**Interim Submission**  
**Pending resolution of issues associated with access to the**  
**Bay and Basin Leisure Centre precinct**

**SHOALHAVEN CITY COUNCIL**  
**ENVIRONMENTAL ASSESSMENT SUBMISSION TO THE NSW DEPARTMENT**  
**OF PLANNING**  
**PART 3A, ENVIRONMENTAL PLANNING & ASSESSMENT ACT, 1979**

**MAJOR PROJECT APPLICATION MP 06\_0205**  
**Modification No 2**

**PROPOSAL:** Proposed MP06\_0205 VDC Stage 1 - Modification No 2 being modification to the VDC Stage 1 approval by delivery of the VDC is two stages with Stage 1 now being approx 22,600m<sup>2</sup> and the future Stage 2, being approx 9400m<sup>2</sup> floor area, and associated arrangements; and the delivery of various off-site works before occupation of the VDC Stage 1.

APPENDIX 1 - Proposed Option 4

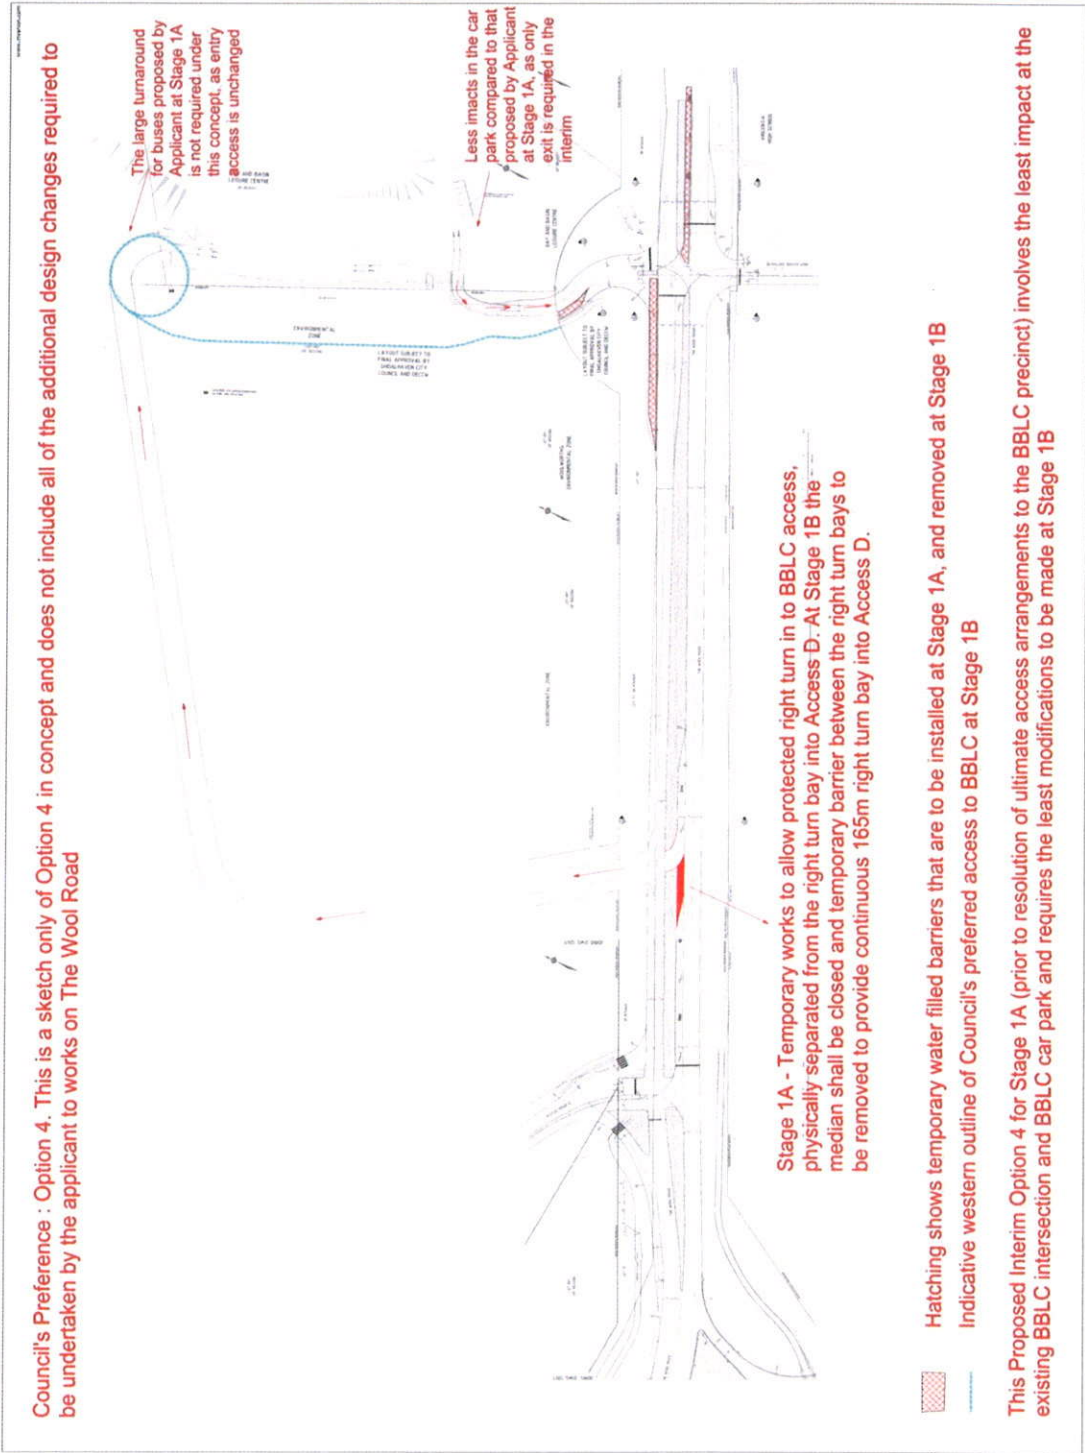
Council recommends an additional Option 4 be considered by the proponent as an amendment to the modification that will see completion of maximum work within the Wool Road as Stage 1A and provision of minimal temporary arrangements and work as part of Stage 1B. The continued use of the existing BBLC access road as a one-way route until the ultimate new BBLC access can be resolved. All the ultimate work within Stage 1A and 1B will be achieved ultimately and will be incorporated in to the SoC. Option 4 is explained in detail below and a plan representing Option 4 is attached as Appendix 1

*On that basis an "interim" exit only strategy for Access E will allow the full works along The Wool Road to be provided with the only change from ultimate being;*
